Community guide to *The Crescent overpass and active transport links Modification – Design Amendment Report*

April 2020

Design Amendment Report April 2020 (amended Modification design)

Design improvements to the proposed Modification to the M4-M5 Link (Rozelle Interchange) – we’ve listened and made significant changes

Figure 1-1: from the *Design Amendment Report*: The revised design

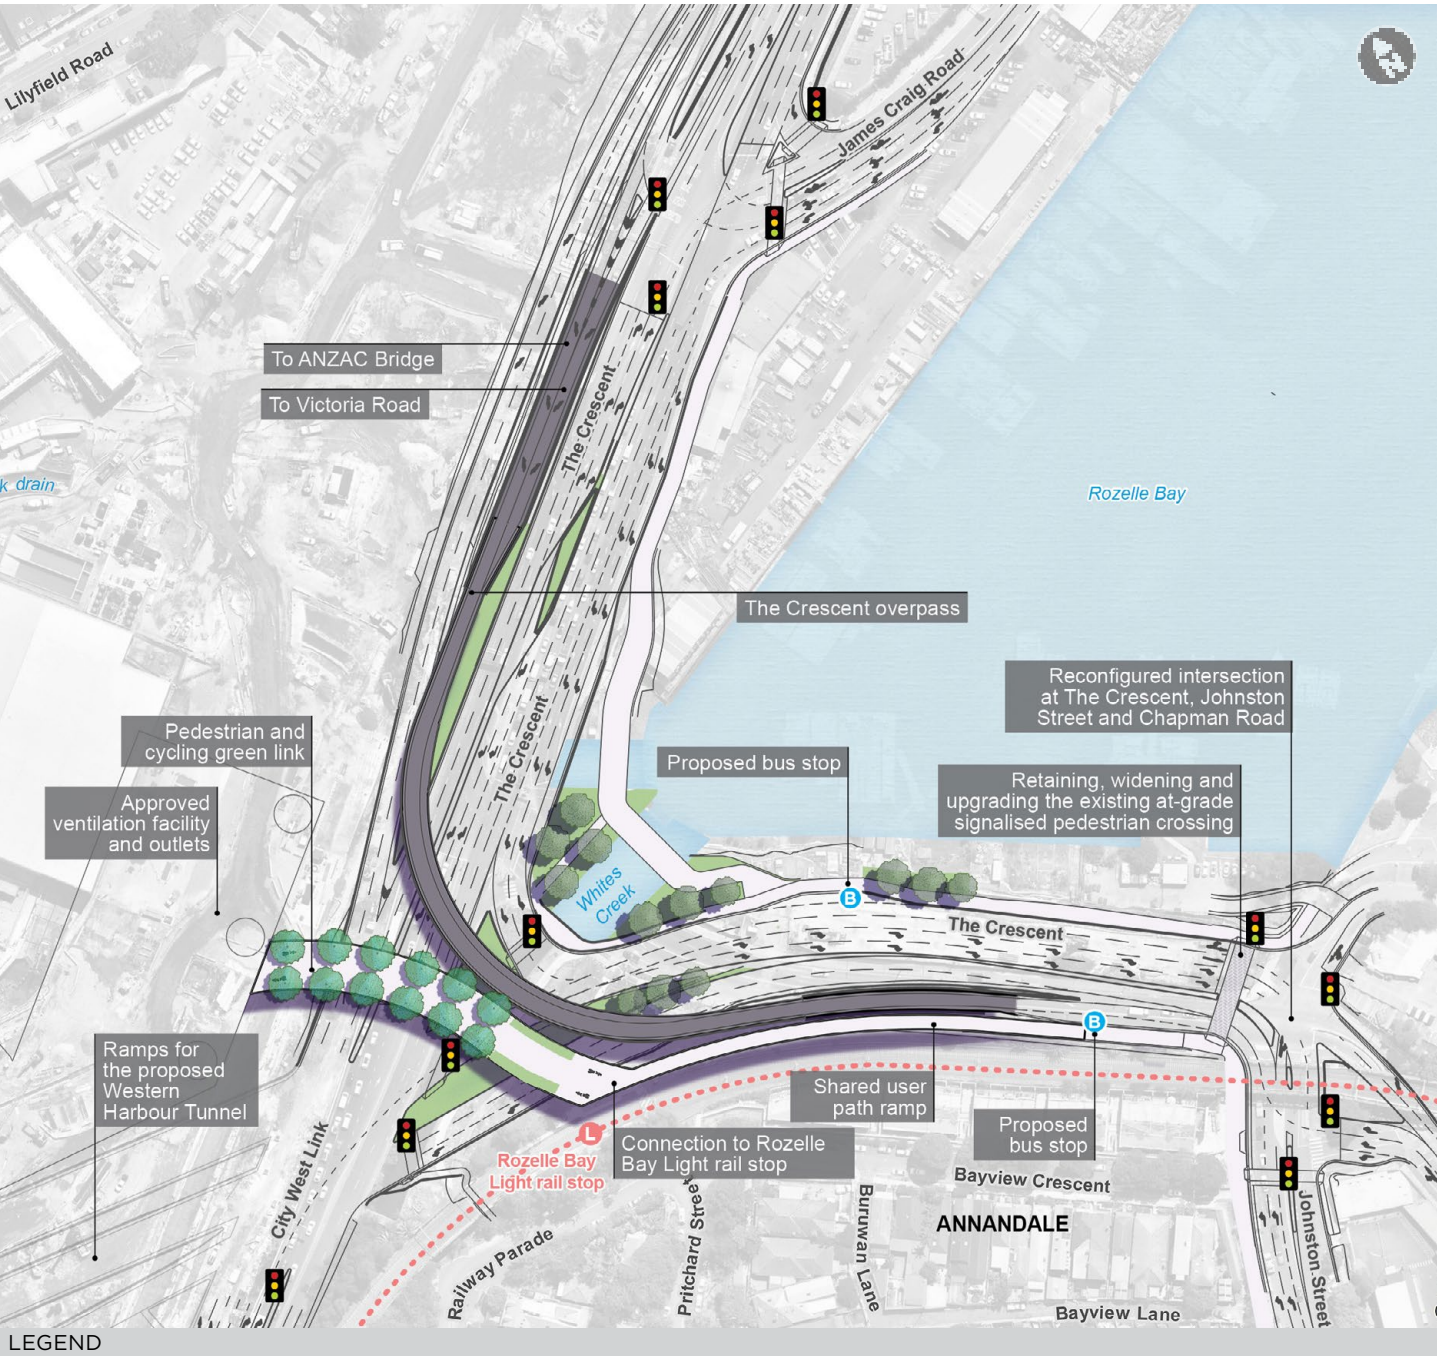
Changes made to the revised design

Figure 2-1 from the *Design Amendment Report*: The revised design – the overpass (long section), indicative view north-west of the revised design

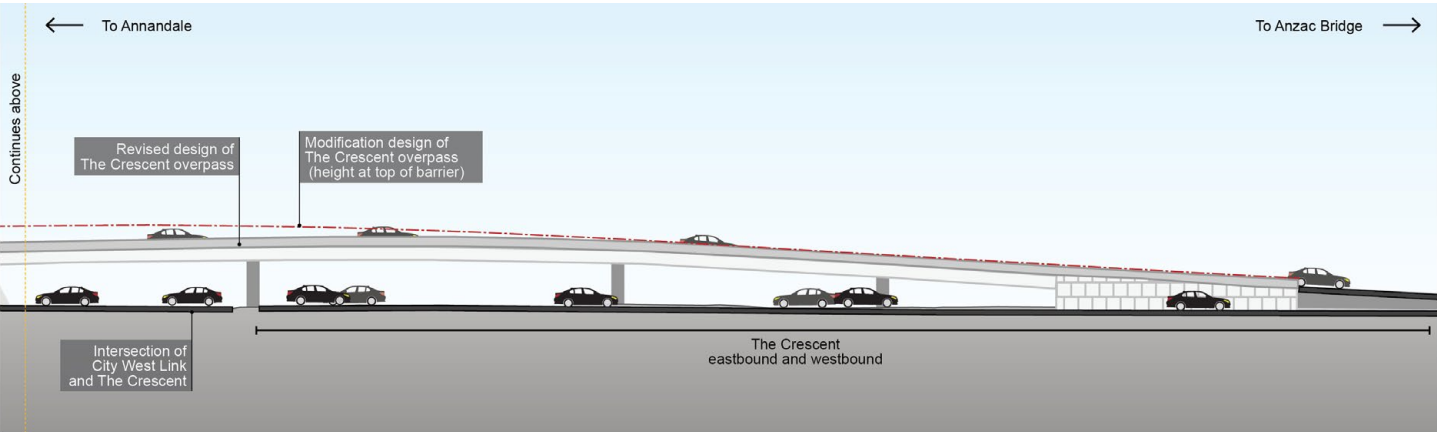
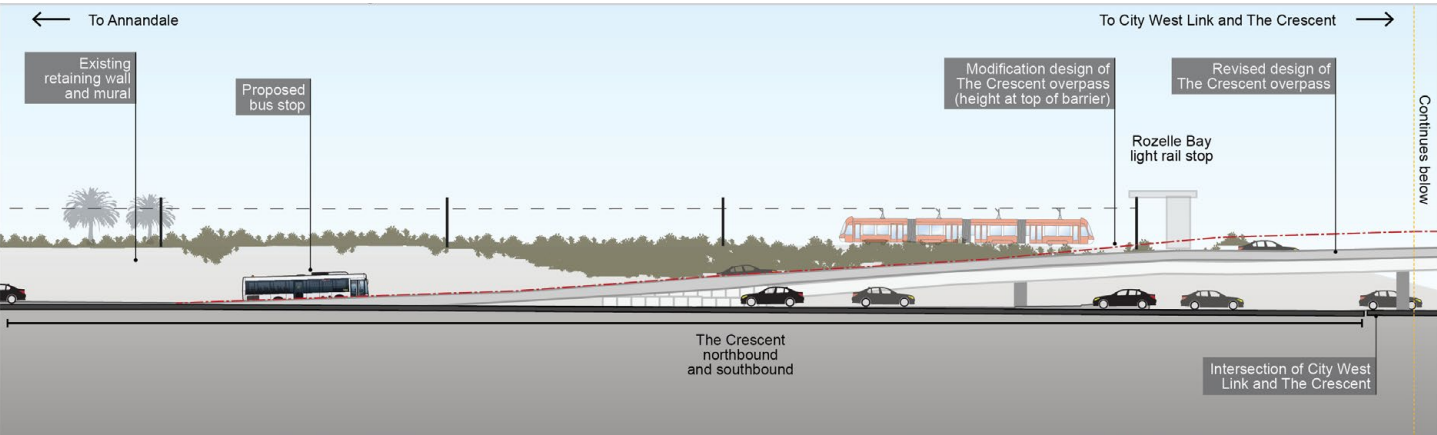
In response to the feedback received in submissions and community and stakeholder workshops, the amended design is lower by around two metres at its apex - making it a similar height to the pedestrian and cyclist green link (bridge). This proposed improvement reduces the visual impact of the overpass, and improves the visual amenity and urban design outcomes for people using the pedestrian and cyclist green link (bridge), providing better views towards Rozelle Bay, ANZAC Bridge and the city skyline.

Figure 3-1 from the *Design Amendment Report*: Revised design - pedestrian and cyclist active transport connections

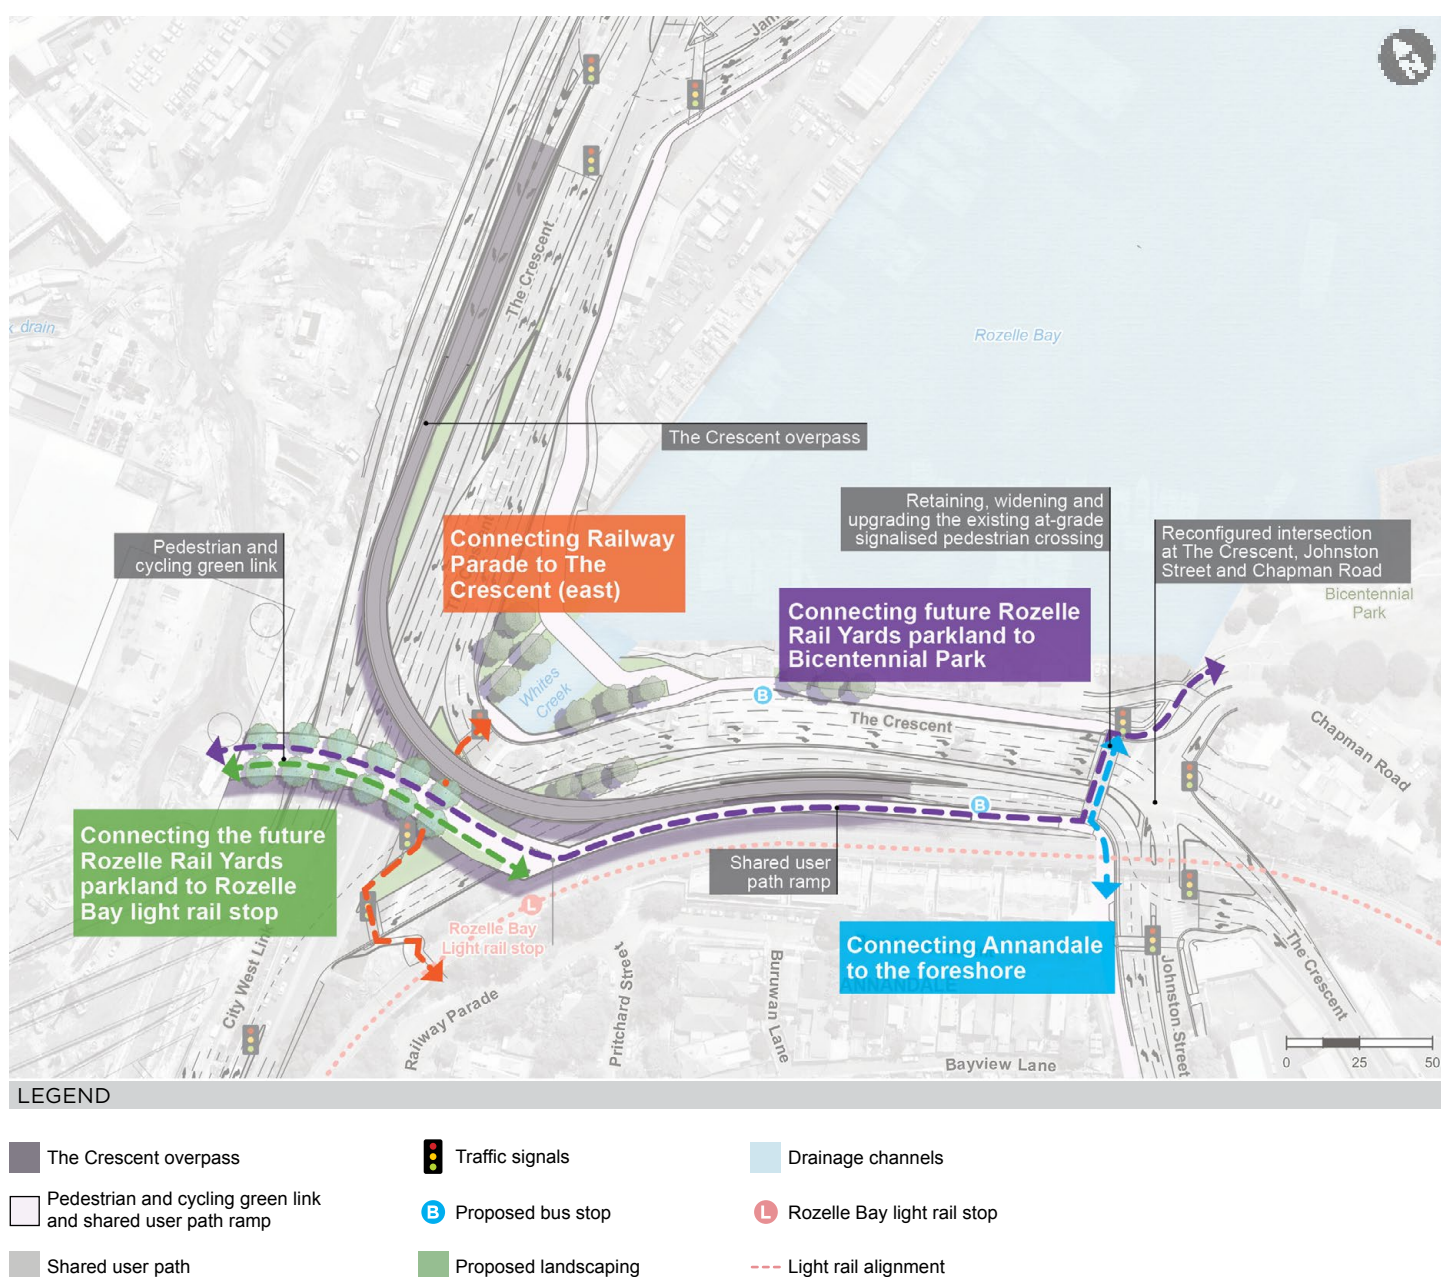
Following community feedback and through the design review process, we are no longer proposing to construct this bridge.

We believe the proposed horse shoe shaped bridge is no longer required due to the following additional proposed improvements:

- the amended design includes a widened and upgraded signalised crossing of The Crescent to connect with Chapman Road and the foreshore area
- pedestrian and cyclist connection is provided between Rozelle and Annandale via the green link bridge
- the amended design includes a widened 4.5 metre shared user ramp from the Rozelle Bay light rail stop to the west side of The Crescent.

Figure: Improvements at The Crescent / Johnston Street / Chapman Road intersection

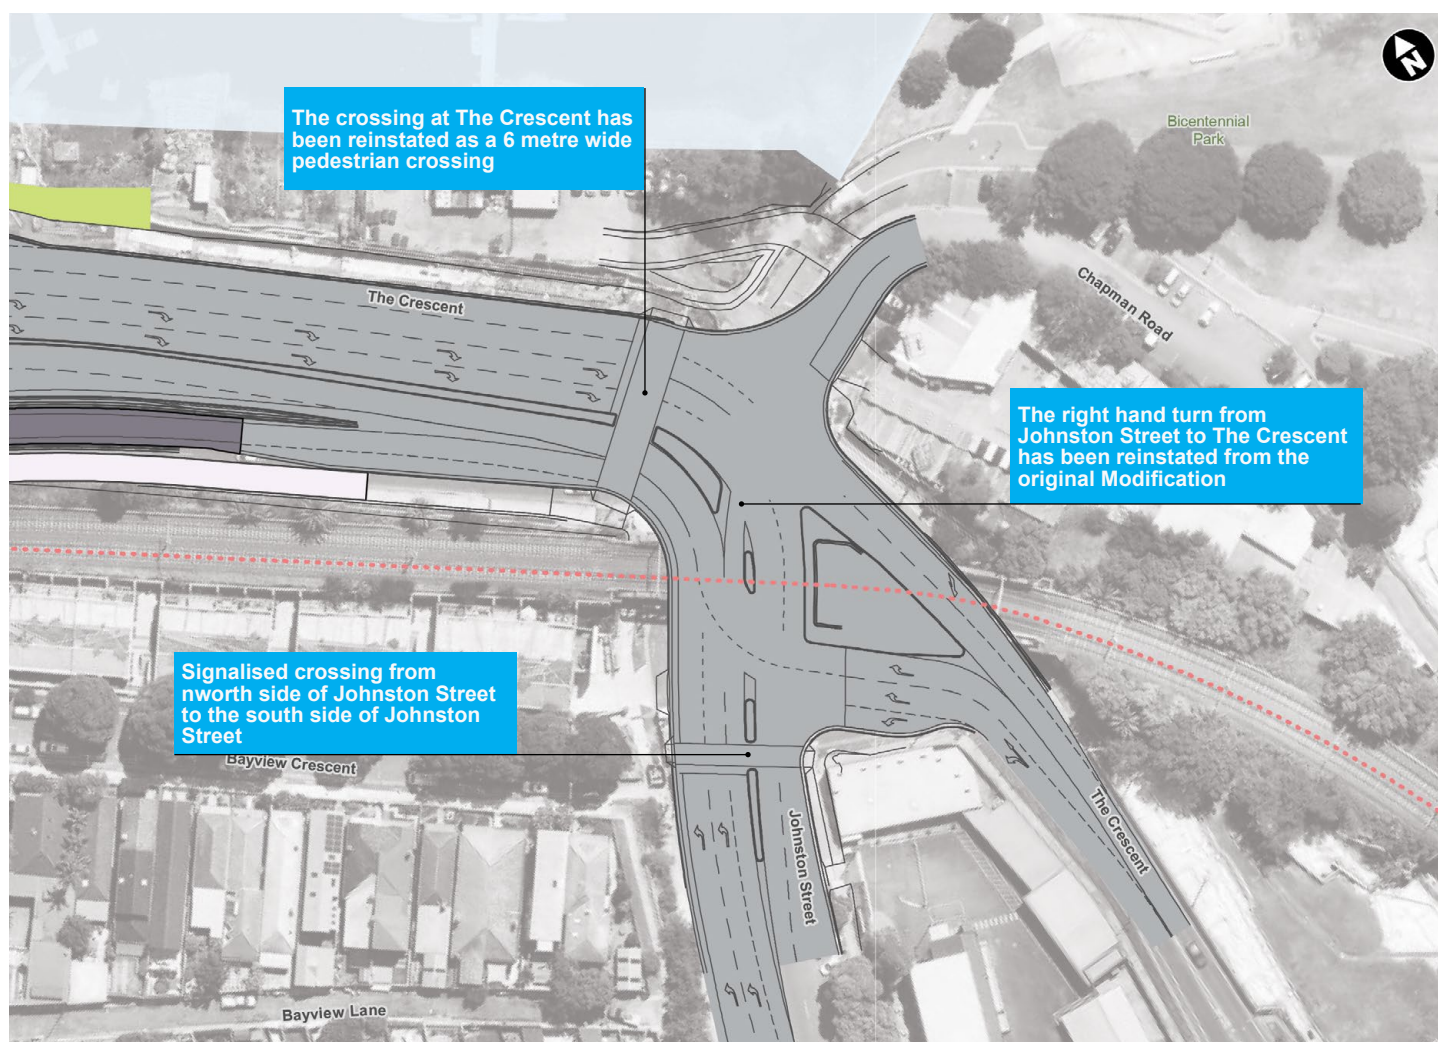
In response to the feedback received from submissions and community and stakeholder workshops, a design improvement is proposed for The Crescent / Johnston Street / Chapman Road intersection enabling a direct crossing for pedestrians and cyclists. We are proposing to retain and upgrade this crossing to provide the final section of the active transport link between the new park at the Rozelle Rail Yards, Rozelle Bay light rail stop, the west side of The Crescent and Chapman Road and the Rozelle Bay foreshore. This will also maintain the important existing connectivity between Annandale and the Rozelle Bay foreshore. These upgrades include:

- where possible, widening footpath and shoulder areas in the vicinity of the crossing to provide additional capacity for pedestrian groups waiting to cross The Crescent
- widening the crossing to six metres, including a pavement change and bicycle lanterns to highlight the pedestrian and cyclist zone
- an indented bus bay on The Crescent providing an area for bus passengers and improving the safety of motorists turning left from Johnston Street onto The Crescent.

Due to this proposed improved design, the multiple crossings at The Crescent and Chapman Road, detailed in the proposed Modification report, are no longer required. There are now only two signalised crossing changes proposed:

- west side of The Crescent to Chapman Road (described above)
- north side of Johnston Street to the south side of Johnston Street.

The right-hand turn from Johnston Street to The Crescent southbound has also been retained, following feedback received during the August 2019 exhibition.
